Technical Service Bulletin

94 Moisture accumulation in headlamps

94 13 20 2028277/7 July 3, 2013. Supersedes Technical Service Bulletin Group 94 number 13-11 dated March 6, 2013 for reasons listed below.

Model(s)	Year	VIN Range	Vehicle-Specific Equipment
Q7	2010 - 2014	All	Not Applicable

Figure 3. Mounting of updated ventilation hose.

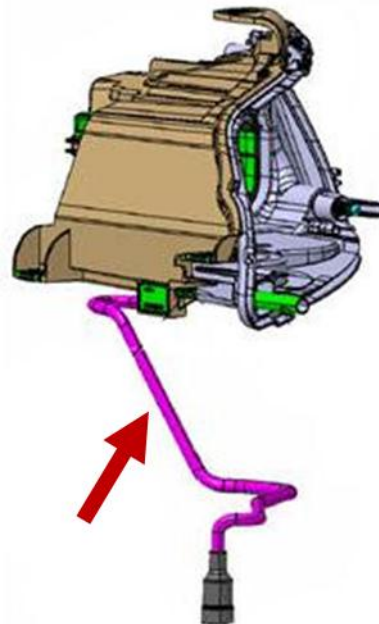
**Tip:** The updated ventilation hose is not connected directly to the headlamp housing. The hose routes downward from the headlamp carrier and between the radiator and bumper (Figure 3, arrow).

Figure 4. Headlamp ventilation guide tube.

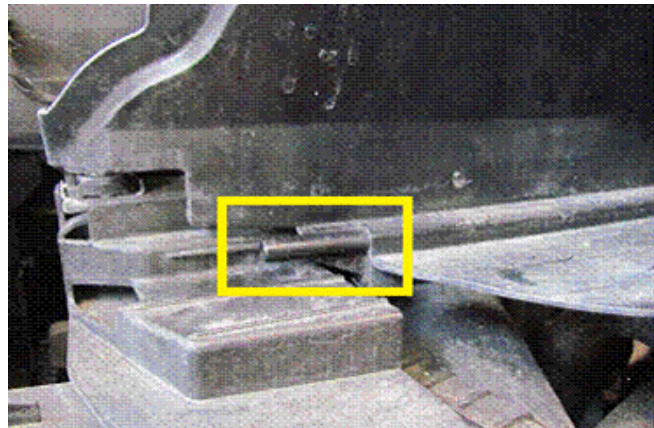
- Each headlamp air ventilation tube must be sealed to protect against further moisture ingress (Figure 4).

Figure 10. View of exit air duct affixed to mounting hook.

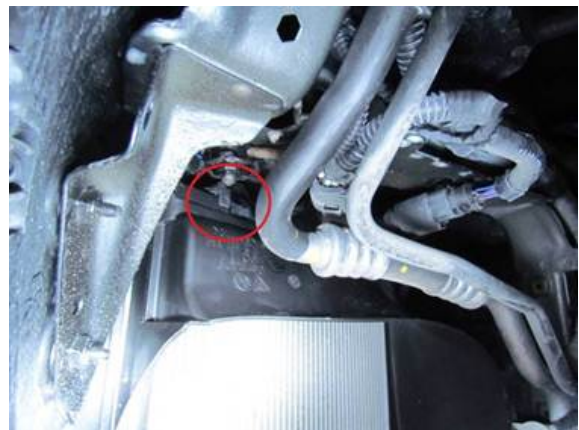
10. Inspect exit air duct attachment points to be sure that ducts are engaged properly over charge air cooler hooks (Figure 10).
